LETTER-LLB-13668

**Subject: Ancillary Facilities Management Plan Revision 43 – Update for Wilson Rd Compound demobilisation and rehabilitation.**

## Attachment A – Wilson Rd Compound Site Diagram

NORTHCONNEX  
 SURFACE - WILSON RD ZONE  
 COMBINED WORKS - CIVIL WORKS  
 PAVEMENT LAYOUT

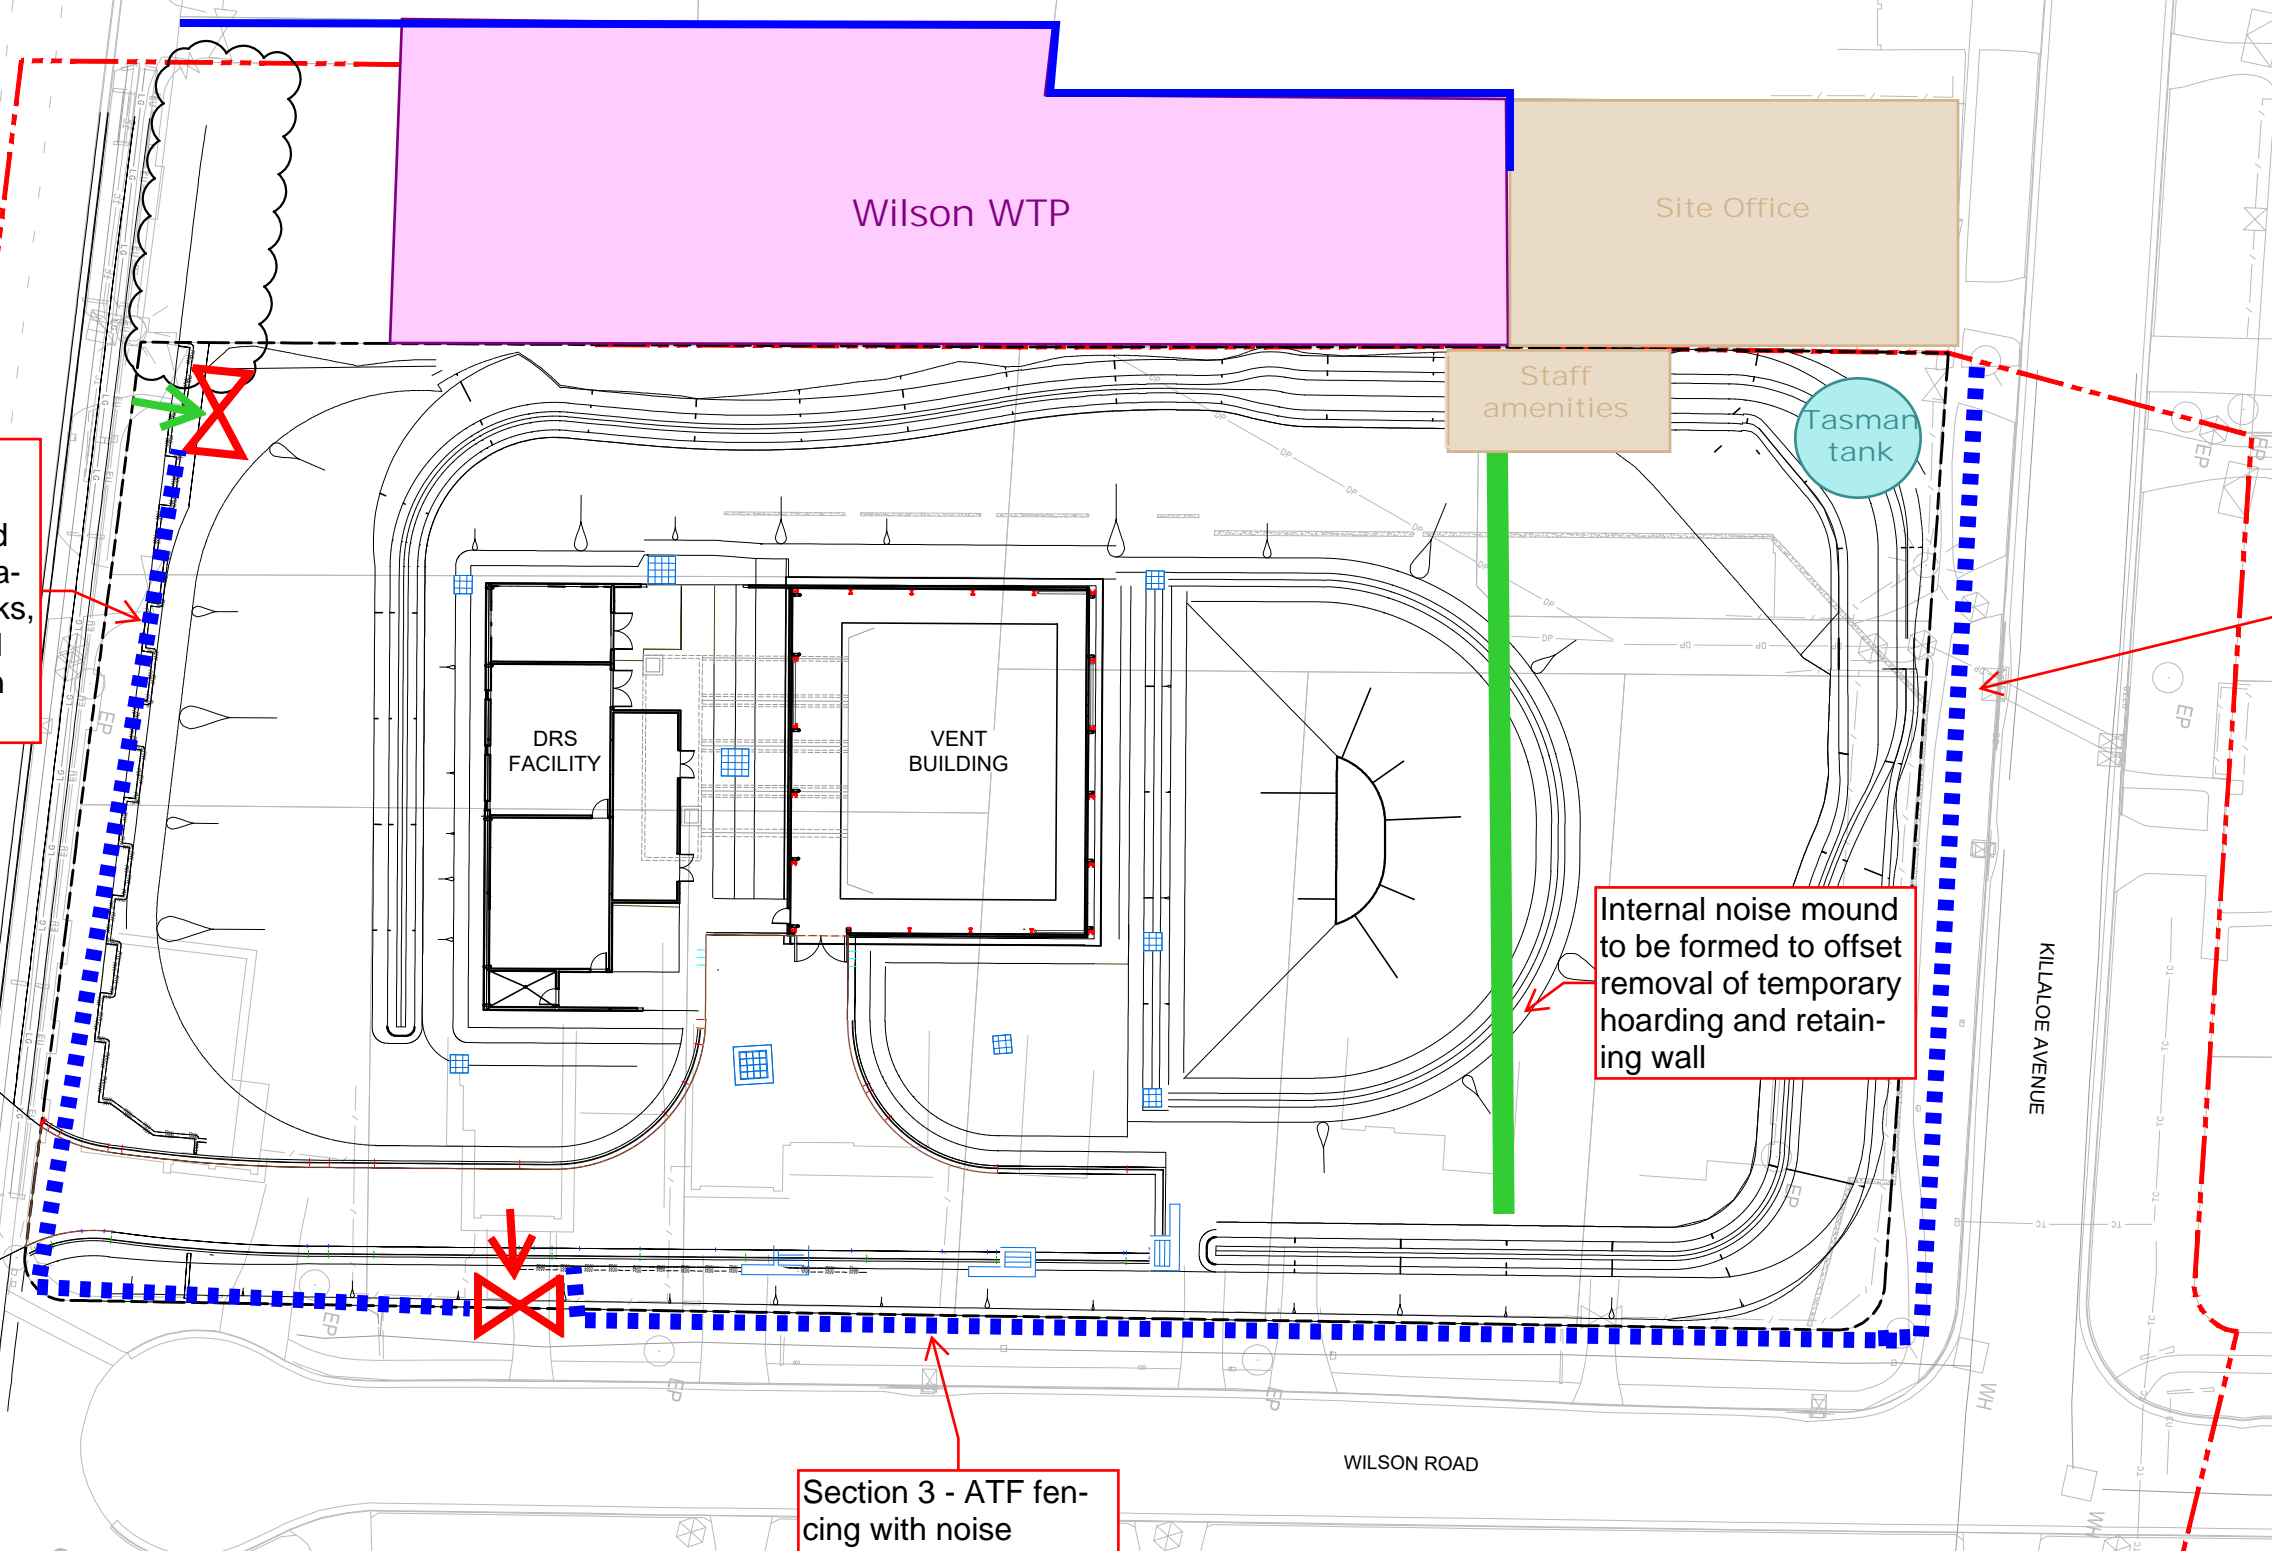
Section 2 - ATF fencing with noise blankets installed mid December 2019, to facilitate final earthworks, landscaping and final fence/wall installation

Section 1 - ATF fencing with noise blankets installed November 2019, to facilitate earthworks associated with former retaining wall

Internal noise mound to be formed to offset removal of temporary hoarding and retaining wall

Section 3 - ATF fencing with noise blankets installed mid/late December 2019, to facilitate final earthworks, landscaping and final fence/wall installation
